**CABINET MEMBER FOR HIGHWAYS MANAGEMENT – 16  
DECEMBER 2021**

**OXFORD: HEADINGTON QUARRY CONTROLLED PARKING ZONE –  
PROPOSED AMENDMENTS TO WAITING RESTRICTIONS**

Report by Corporate Director, Environment and Place

Drawing title  
**ZONE AMENDMENTS  
 PROPOSED NEW DOUBLE YELLOW LINES  
 TRINITY ROAD**

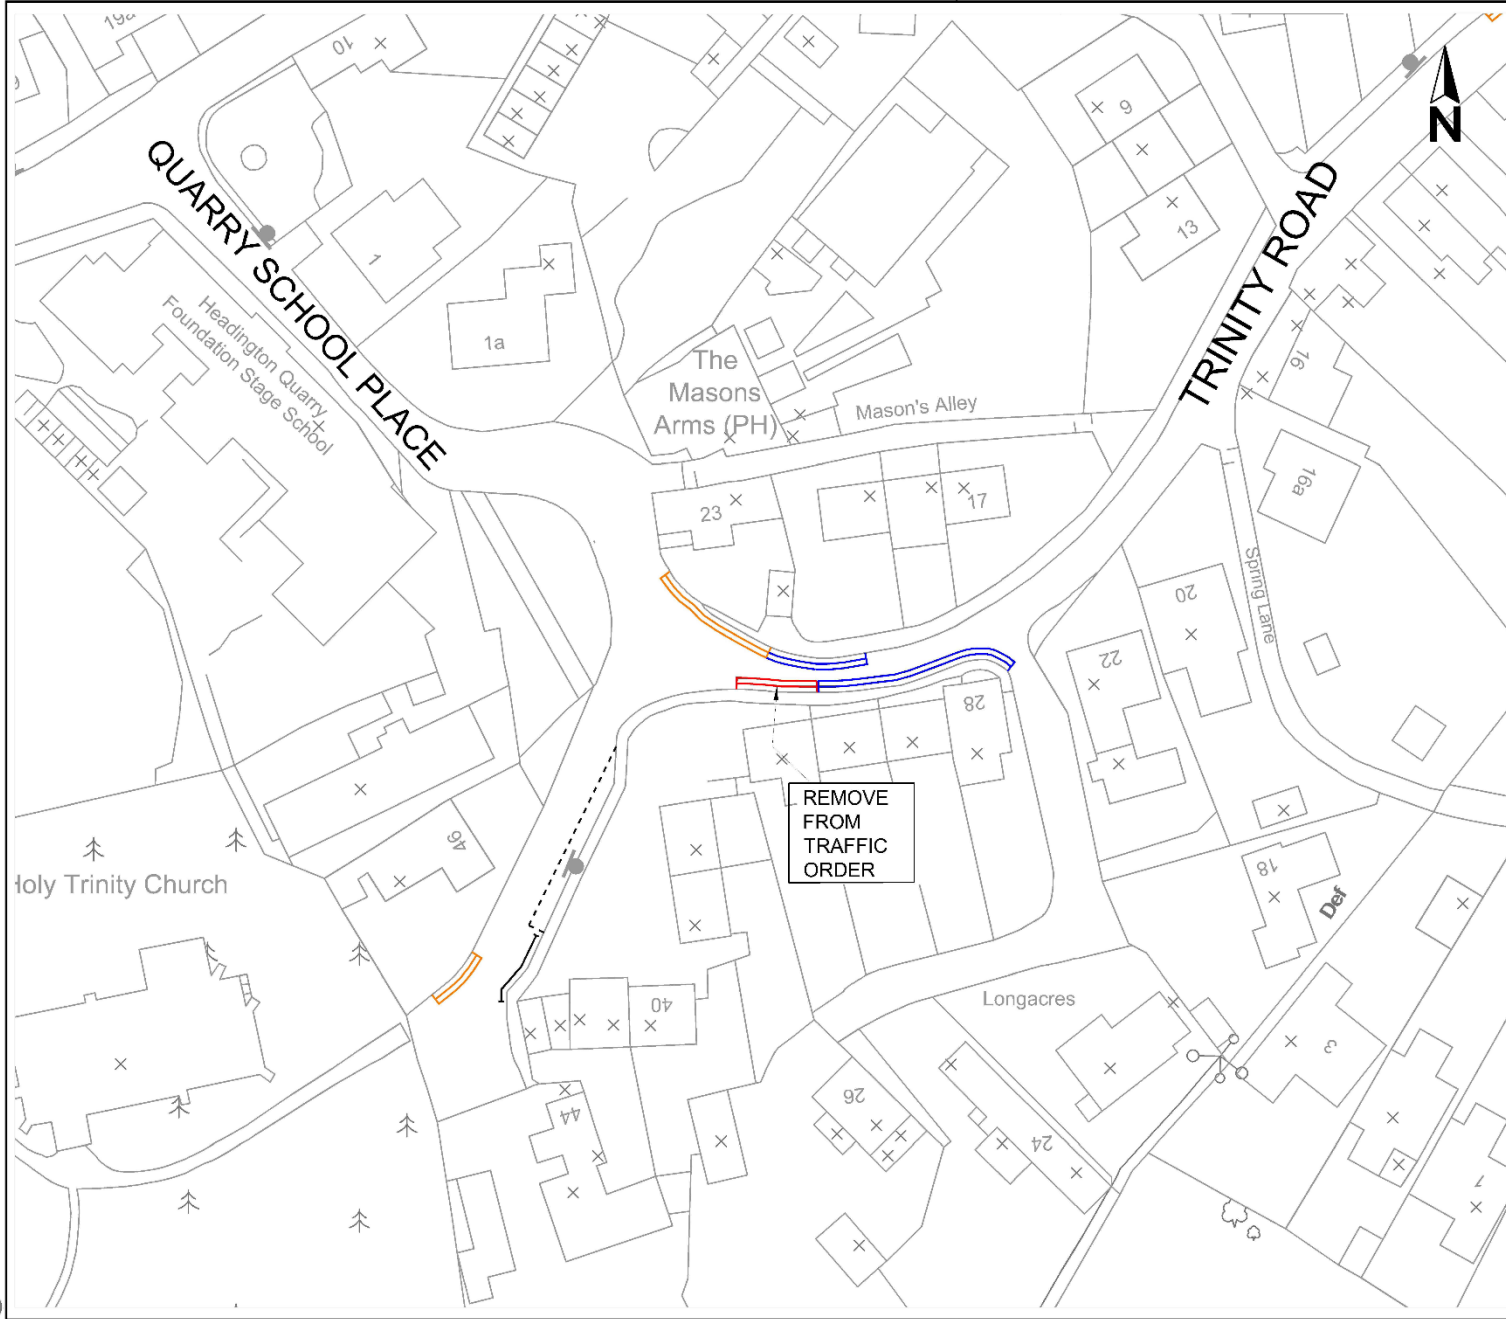
RESPONDENT	COMMENTS
(1) Traffic Management Officer, (Thames Valley Police)	<b>No objection</b>
(2) Oxford Bus Company	<b>No objection</b>
(3) Local County Cllr, (Headington Quarry Division)	<p>Trinity Road (DYLs) - <b>Object</b></p> <p>I agree with the objections to the extension of DYLs on the south side of Trinity Road. The road narrows here and I think we should leave space for parking as these homes do not have off road parking.</p>

(8) Local Resident, (Oxford, Trinity Road)	<p>Trinity Road (DYLs) - <b>Object</b></p> <p>Please do NOT implement the proposal for the south side of Trinity Road, as follows: Trinity Road – a) new extension to existing restrictions on the north side; east of the junction with Quarry School Place, and on the south side outside property Nos. 28-32, b) remove a section on the south side outside property No. 34.</p> <ul style="list-style-type: none"> <li>• I strongly object to this. I am grateful that there will not be yellow lines outside my house (no 34) but my neighbour at no 30 also needs to park.</li> <li>• We have both paid for our permits with the reasonable expectation that there would be places where we can park. It is obvious that there are no other options for us to park anywhere in the neighbourhood, other than outside our houses on the south side of Trinity Road. The waiting zone further down Trinity Road towards the church is nearly always fully occupied with cars. The area marked with an X is unsuitable for long-term parking as the tree drops a sap which is difficult to remove from cars.</li> <li>• The residents at no's 32 and 28 are chronically ill and/or elderly and space is needed for their visitors/carers when they stop by.</li> <li>• I don't understand the need for the double yellow lines. (Your website lists a document called 'Statement of reasons' but no reasons are given.)</li> </ul>

<ul style="list-style-type: none"> <li>• Provided that we park slightly on the pavement, allowing enough space for children’s strollers/wheelchairs to get past safely, the road is wide enough for large vehicles such as dustbin lorries to get past. I am not aware that there have been any issues relating to this. Please see the attached photos. Large vehicles are much more likely to be blocked where the road is narrower further east.</li> </ul> <p>Thank you for consulting with us and I sincerely hope you will be able to implement your other proposals but leave this section of Trinity Road alone. Or, at most, place a very short section of double yellow lines on the corner of Trinity Road and the lane that leads down to no 22 and other houses.</p>
<p>(9) Local Resident, (Oxford, Trinity Road)</p>	<p>Trinity Road (DYLs) - <b>Object</b></p> <p>I am perturbed by the Trinity Road proposal (a) new extension to existing restrictions on the north side; east of the junction with Quarry School Place, and on the south side outside property Nos. 28-32. I have lived here for many years and, although cars are generally parked outside numbers 23-32, they have not prevented the passage of other vehicles, including those as large as refuse lorries.</p> <p>Parking at this end of Trinity Road is scarcely enough for one car per household as it is; fortunately for us, not all households have cars and we are now generally able to find parking reasonably close to home. However, there are frequently visitors to the nearby church and school plus visiting carers and trades people who require parking. The reduction in available parking will impact on all of the users as well as residents.</p> <p>The lay-by at the front of my house allows 2-hour visitor parking during operational hours of the CPZ. While parking is permitted on the corner opposite my house (at the top of Quarry School Place), sap from the trees mean it is potentially damaging to cars to be placed there for any length of time. One thought is that the lay-by could be made residents only and a 2-hour permitted space set up under the trees instead.</p>

<p>2. Leaving no opportunity to park for at least 4 homes and all visitors.</p>
<p>(44) Local Resident, (Headington Quarry, Trinity Road)</p>	<p>Trinity Road (DYLs) - <b>Object</b> Trinity Road (2hr) - <b>Object</b></p> <p>I live in this road. The double yellow lines protect both of the entrances to my house from having cars parked across them. This happens frequently and the permits have not stopped this. Parents from the school during the day disregard the gates and pub patrons at night disregard anyway. Ensuring the gates are clear allows me to get my bikes in to and out of my property. PLEASE DO NOT REMOVE THE LINES AROUND 23!!!!</p>
<p>(45) Local Resident, (Headington Quarry, Trinity Road)</p>	<p>Trinity Road (DYLs) - <b>Object</b> Trinity Road (2hr) - <b>Support</b></p> <p>I support the proposed 2 hour parking outside Six Bells, which will provide useful extra capacity for mid-week visitors.</p> <p>I object to the proposed south side changes outside 28-32 Trinity Road. I don't live in these houses but am concerned that preventing parking outside them will reduce the total capacity on the street by 3-4 spaces, thus making it much harder for residents all along the street to find evening parking slots. The south side pavement ends by no. 28, so pedestrians all cross to the north pavement anyway, so having cars parked along this stretch does not create an obstruction.</p> <p>I don't understand the annotation "REMOVE FROM TRAFFIC ORDER" outside no. 34 Trinity Road as there are no road markings here at present. Please reissue this map with an annotation that clarifies your intentions for this stretch. Thanks.</p>

- b) Not approve the proposed additional ‘no waiting at any time’ (double yellow lines) in Gladstone Road outside No. 35
  - c) Approve the proposed additional ‘no waiting at any time’ (double yellow lines) as advertised on the Northern side of Trinity Road outside No. 21

- d) Not approve the proposed additional ‘no waiting at any time’ (double yellow lines) on the Southern side of Trinity Road.
  - e) Not approve the proposed ‘no waiting at any time’ (double yellow lines) in Quarry High Street & Bushnell Close.

13. A large majority of the responses received expressed an objection or cited concern over the impact that the proposed introduction of double yellow lines in Gladstone Road, Quarry High Street and Trinity Road would have on parking availability for residents and their visitors. Following discussion with the local County Councillor and whilst balancing the demand for parking and ensuring that safer passage for motorists and pedestrians is not impacted, a review of the advertised extents of proposed double yellow lines should be considered.

Drawing title  
**ZONE AMENDMENTS  
PROPOSED NWAT - BUSHNELL CLOSE  
PROPOSED 2 HOUR PARKING  
TRINITY ROAD, GREEN ROAD & PITTS ROAD**

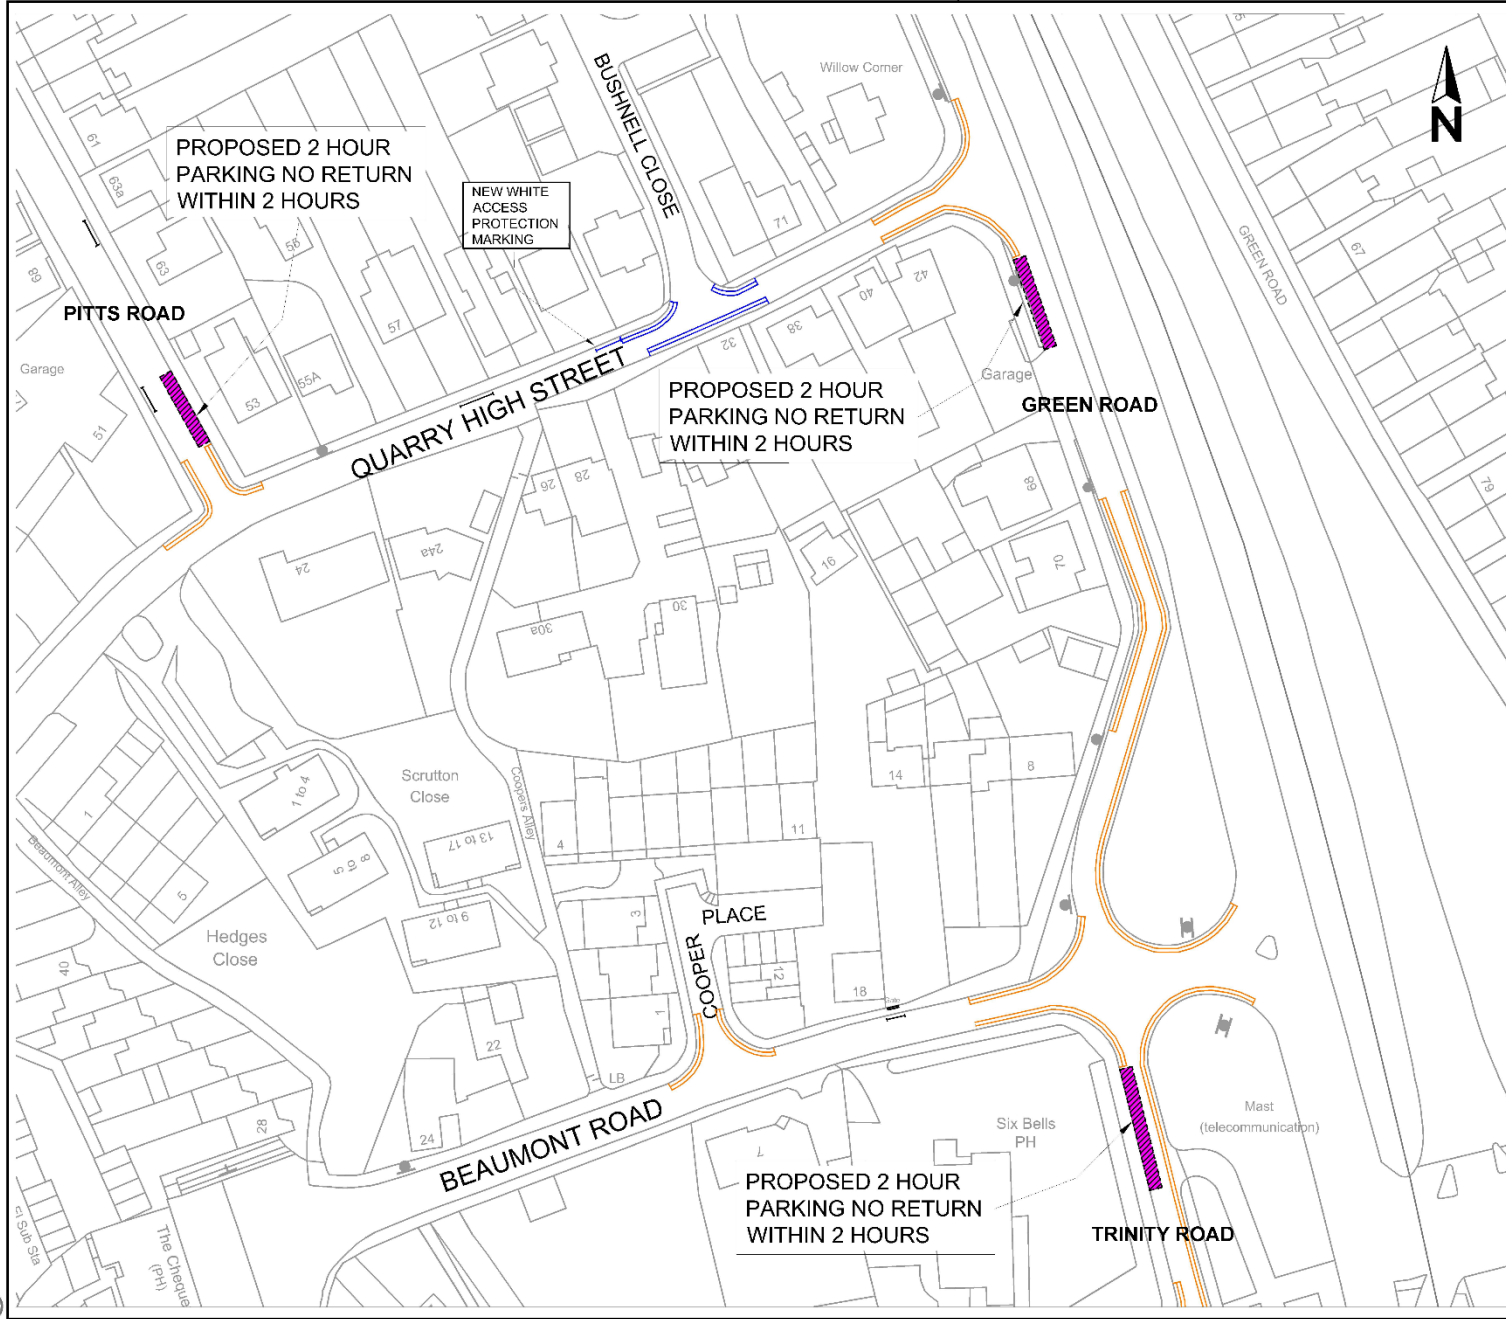
(4) Local City Cllr, (Quarry & Risinghurst Ward)	<p>Quarry High Street (DYLs) - <b>Concerns</b>                      Green Road (2hr) - <b>Concerns</b>                      Pitts Road (2hr) - <b>Concerns</b></p> <p><b>Concerns</b> – My concerns are the impact of these restrictions and CPZ on the two businesses in Quarry namely Quarry Motoring Centre Garage and Pitts Road Garage.</p> <p>The suggested option was to Issue Quarry Motoring Centre six and Pitts Road garage three parking passes to enable them stay in business. The other option is for four hours parking bays outside these garages.</p>

<p>My main concerns are the introduction of double yellow lines on Quarry High St on both sides opposite the entrance to Bushnell Close. The proposed lines on the northern side of the road go directly across my driveway on Quarry High Street. As your letter indicates that the proposals are a result of engagement with residents, I'm surprised we were not informed of this proposed change directly. In the 11 years I have lived in this property, no one has ever parked in this space or the space marked on the other side of Bushnell Close, apart from occasional deliveries, so the introduction of yet more street markings seems entirely unnecessary.</p> <p>I am also at a loss to understand the reasoning behind the proposed double yellow lines on the opposite, southern side of Quarry High St. We are fortunate to have a driveway but other residents are not so fortunate and this provides one of the few places in this area where residents can park on the street and where delivery and tradespeople can stop. These parking spaces make it more difficult for us to access our drive but we recognise that they are important for others. The council also needs to recognise the changed world we live in where many more people work from home so are present in residential areas during the day.</p>

<p>(11) Local Resident, (Oxford, Quarry High Street)</p>	<p>Quarry High Street (DYLs) - <b>Object</b></p> <p>I would like to object to the addition of double yellow lines on the section of Quarry High Street opposite Bushnell Close, as this would rule out any option to park near to my house. Myself and my neighbour are fully reliant on on-street parking, having no driveway access at our houses and the proposed changes would lead to us having to park further from our houses- this loss of available parking space would also then create more congestion and competition for parking further down Quarry High Street (towards Pitts Rd) as many of these houses also rely solely on the on-street parking.</p> <p>The very recent addition of controlled parking zones on QHS and surrounding roads have already created a need to pay for permits (and this is not an insignificant cost), and the proposed changes would make it difficult to actually use these permits as I would no longer be able to park anywhere near my house?</p> <p>The road area opposite Bushnell close is neither particularly busy, nor narrow, so I won't pretend like I fully even understand the need for further parking restrictions in this area.</p>

<p>I visit this area as a customer of the Garage on Green Road. More double lines will make it even worse to park around there. Bays are a good idea but two on Green Road is not enough and they need to be four-hour parking bays not two. That will make it much easier to drop your vehicle off.</p>
<p>(19) Resident, (Eynsham, Back Lane)</p>	<p>Gladstone Road (DYLs) - <b>Object</b>          Trinity Road (DYLs) - <b>Object</b>          Quarry High Street (DYLs) - <b>Object</b>          Green Road (2hr) - <b>Object</b>          Pitts Road (2hr) - <b>Object</b>          Trinity Road (2hr) - <b>Object</b></p> <p>My daughter lives in the family house built by her Great, Great, Great Grandfather. My husband (also quarry born &amp; bred) &amp; I like to visit &amp; we cannot walk very far anymore. These plans would isolate Quarry from outsiders with nowhere to park. Several houses have no driveway or garage &amp; have to leave their vehicles on the roadside, making it difficult to visit now without further restrictions. Quarry, with its history, is an attractive area &amp; the church is especially so. Putting in any restrictions makes int impossible to visit. Car access is vital for getting to visit relatives. Please reconsider all your plans as they are totally inappropriate for this area.</p>

<p>(28) Local Resident, (Oxford, Pitts Road)</p>	<p>Pitts Road (2hr) - <b>Object</b></p> <p>Overall, we are content with the majority of the changes but not to the proposal to put two 2-hour parking bays opposite the garage in Pitts Road. Our reasons for this are based on the cavalier approach of the garage to the existing controlled parking zone. The garage simply ignores this and parks cars throughout the area on Quarry High Street, New Cross Road and Pitts Road. As shown in the photograph, frequently the entire Quarry High Street end of Pitts Road is parked on both sides, with large vehicles blocking the pavement opposite 5 Quarry High Street. Even today, the garage had 10 vehicles parked at this end of the street and once again blocking the pavement thus forcing push-chair users, mobility scooter users and pedestrians to move into the already restricted road.</p> <p>On the basis of this continued lack of consideration by the garage we can see no useful purpose is gained by adding two short stay parking bays to this end of the road and it smacks of rewarding the antisocial behaviour of the garage. Better by far would be to place a parking restricted sign on the lamp post opposite the garage at this site to remind them and their customers of the presence of the CPZ. In addition, it would be good to see more stringent enforcement of the CPZ to prevent the garage gaming the system by moving cars around when the wardens appear and then replacing them when the wardens have gone. It is interesting to note how few cars parked close to the garage ever get tickets whereas those elsewhere do get ticketed. Of the 10 vehicles parked at that end of Pitts Road today none have been ticketed at the time of writing.</p> <p>We understand the desire to maintain small businesses in residential areas. However, the rights of the businesses to operate in such areas surely demands that they be considerate of their neighbours with respect to pavement access, restricting the road and noise.</p>

<p>(38) Local Business, (Oxford, Green Road)</p>	<p>Quarry High Street (DYLs) - <b>Object</b> Green Road (2hr) - <b>Object</b></p> <p>As business owner of Quarry Motoring Centre I object to the bays outside the garage. The bays in themselves are a good idea but two bays are simply not enough. There needs to be far more and they need to be four hours not two. I go the garage every day for a couple of hours and can't park. I also find it difficult visiting my son who lives next door. We only get a few visitor permits which simply is not enough. Four-hour bays would enable me to work at the garage each day and also to easily visit my son. I am also seeing the impact that the parking restrictions are having on the business. It would be much easier for us moving cars in and out and for our customers if there were more bays along the Green Road with four hours parking. The extra double yellow lines just surely make it harder for people as there is less spaces available.</p>

<p>I object to the DYL changes in Quarry High Street opposite Bushnell Close as they will put additional pressure on parking on Quarry High Street, particularly for people who live near the Green Road end where parking is already constrained. I also do not see that they are necessary as there is very limited traffic coming into or out of Bushnell Close at any time</p>
<p>(47) Local Resident, (Risinghurst, Green Road)</p>	<p>Gladstone Road (DYLs) - <b>Support</b>          Trinity Road (DYLs) - <b>Support</b>          Quarry High Street (DYLs) - <b>Support</b>          Green Road (2hr) - <b>Support</b>          Pitts Road (2hr) - <b>Support</b>          Trinity Road (2hr) - <b>Support</b></p> <p>Green Road and Quarry High Street are 2 roads that are constantly block by cars park on double yellow line for whole day while people travel to the London (by bus) or city centre.</p>
<p>(48) Local Resident, (Oxford, Hedges Close)</p>	<p>Gladstone Road (DYLs) - <b>Support</b>          Trinity Road (DYLs) - <b>Support</b>          Quarry High Street (DYLs) - <b>Support</b>          Green Road (2hr) - <b>Support</b>          Pitts Road (2hr) - <b>Support</b>          Trinity Road (2hr) - <b>Support</b></p> <p>More 2 hour spaces is a good thing.          The current restriction on temporary parking in the quarry does not help protect resident's parking or reduce through-traffic. Spaces are not protected for residents after 5pm, when commuters need their spaces. Instead, spaces are left pointlessly empty between 9am and 5pm; these spaces may as well be used.          If the council truly thinks that there is a congestion problem impacting on pedestrians on Quarry Road, Trinity Road, and Quarry High Street (as someone who lives on Quarry High Street, I do not), then pedestrian crossings should be built. The primary traffic problem on Quarry High Street is an absence of marked bays for parking, therefore parking is spread unevenly across both sides of the street, leading to slaloming of cyclists, cars, and the pedestrians who cross the roads, and long queues forming around Gladstone Road/Quarry High Street junction as cars struggle to reach Quarry Road - as someone who lives on Quarry High Street and regularly needs to travel to Old Road via Quarry Road, this is problematic, both when in car and on bicycle due to the uneven parking leading to people struggling to</p>

- f) Approve the proposed ‘Two-hour parking bays (No Return in 2 hours) Mon-Fri 9am to 5pm’ as advertised on Green Road, Pitts Road & Trinity Road but that consideration is given as part of any future amendment Orders to increase the time limit if required.

14. A number of responses received cited concern that the proposed 2 hour parking bays in Green Road and Trinity Road were not suitable for the area and made suggestion to increase the proposed limit to 4 hours and increase the proposed extents of the parking bays, as this would allow for better flexibility for visitors and the local businesses whilst continuing to deter commuter parking – concerns regarding the proposed 2 hour time limit have been recorded, but to note existing time limited parking bays within the Headington Quarry Zone provide up to 2 hours of ‘free’ parking and, therefore, the proposed additional bays follow on with the general design of the zone which also allows for a more balanced and uniformed approach when enforcing the restrictions. Furthermore, it should be stressed that the limit of 2

hours is applied in the majority of all other CPZs across Oxford and there are many businesses that currently operate in these areas. Increasing the limit within the Headington Quarry Zone would set a precedent for similar requests.

Drawing title  
**ZONE AMENDMENTS  
PROPOSED REMOVAL OF DOUBLE YELLOW LINES IN GLADSTONE ROAD**

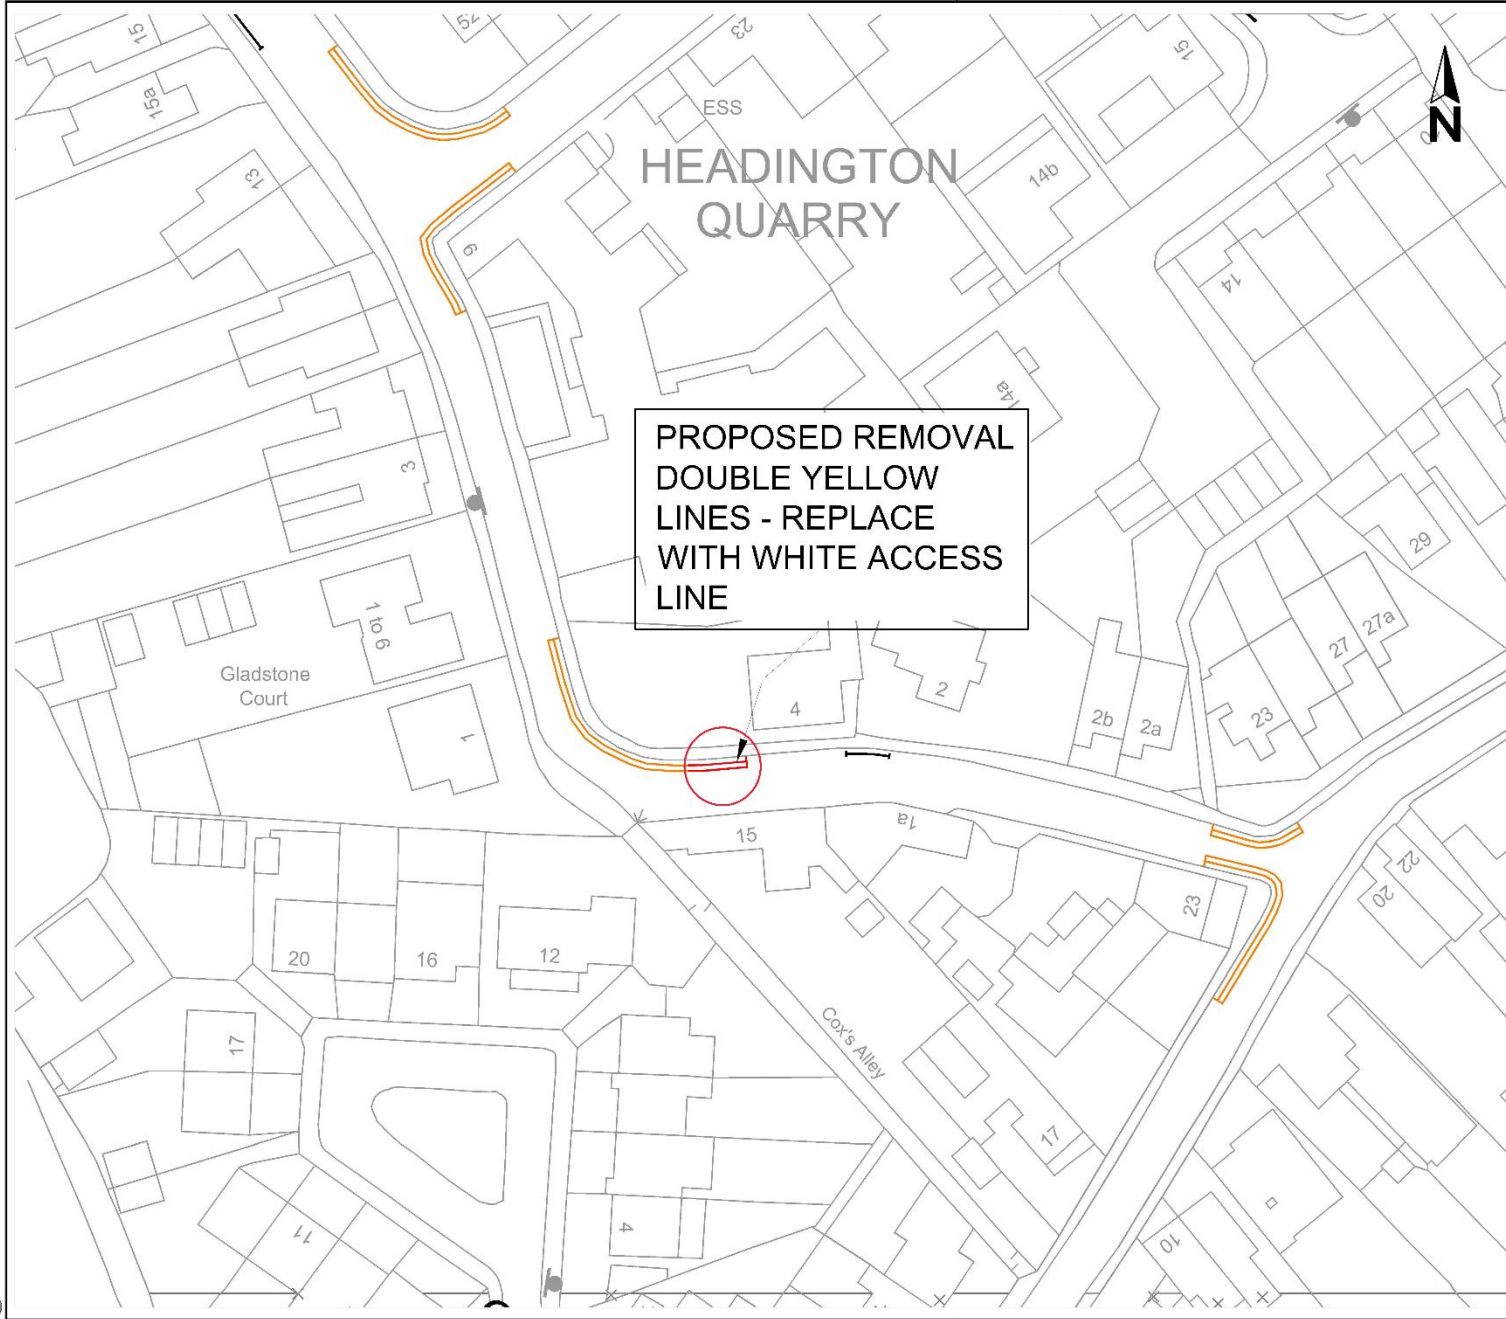
**PROPOSED REMOVAL  
DOUBLE YELLOW  
LINES - REPLACE  
WITH WHITE ACCESS  
LINE**

1. The Cabinet Member for Highway Management is RECOMMENDED to;
  - a) Approve the removal of ‘no waiting at any time’ (double yellow lines) in Gladstone Road outside No. 4.
